Access Compliance Report

(Curb Ramps)

Intersection ID: 22059	Main Street: RICHARD_BARRY_DR	Cross Street: SARDIS_FOREST_DR	Location: NW
ADA ID: 0C6201703D70	Ramp Type: Perp	Initial Pass/Fail: Fail	Overall Compliance: No
Severity Score: 12.5			
Codes/Mitigation Info/Possible Solution		Field Measurements/Component Compliance

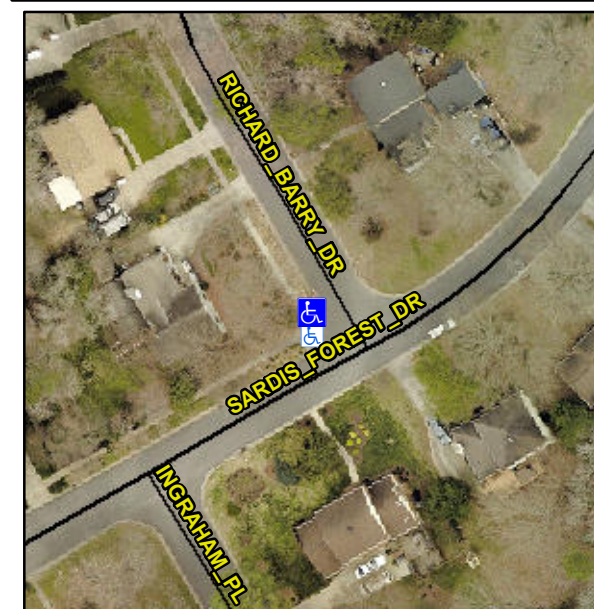
R304.2.2

Compliance	Description	Data	Compliance	Description	Data
N/A	Ramp Length (in)	77.0	No	Ramp Slope (%)	8.9
Yes	Ramp Width (in)	48.0	Yes	Ramp XSlope (%)	1.1
N/A	Flare Type LT	N/A	N/A	Flare Type RT	N/A
N/A	Flare Slope LT (%)	N/A	N/A	Flare Slope RT (%)	N/A
N/A	Flare Traversable LT?	N/A	N/A	Flare Traversable RT?	N/A
N/A	Landing Length (in)	N/A	N/A	DWS Provided?	N/A
N/A	Landing Width (in)	N/A	N/A	DWS Contrast?	N/A
N/A	Landing Slope (%)	N/A	N/A	DWS Length (in)	N/A
N/A	Landing X Slope (%)	N/A	N/A	DWS Full Width?	N/A
N/A	Landing Curb? (Y/N)	N/A	N/A	DWS Offset (in)	N/A
N/A	Shared Landing?	N/A			
N/A	Gutter Ponding?	N/A	N/A	Gutter Slope (%)	N/A
N/A	Gutter Lip Ht (in)	N/A	N/A	Gutter X Slope (%)	N/A
N/A	Painted X Walk1?	No	N/A	Painted X Walk2?	N/A
	X Walk 1 Direction	To NE		X Walk 2 Direction	N/A
N/A	X Walk 1 Width (in)	N/A	N/A	X Walk 2 Width (in)	N/A
	X Walk 1 Slope (%)	2.8		X Walk 2 Slope (%)	N/A
	X Walk 1 X Slope (%)	0.2		X Walk 2 X Slope (%)	N/A

Remove & Replace Entire Ramp.
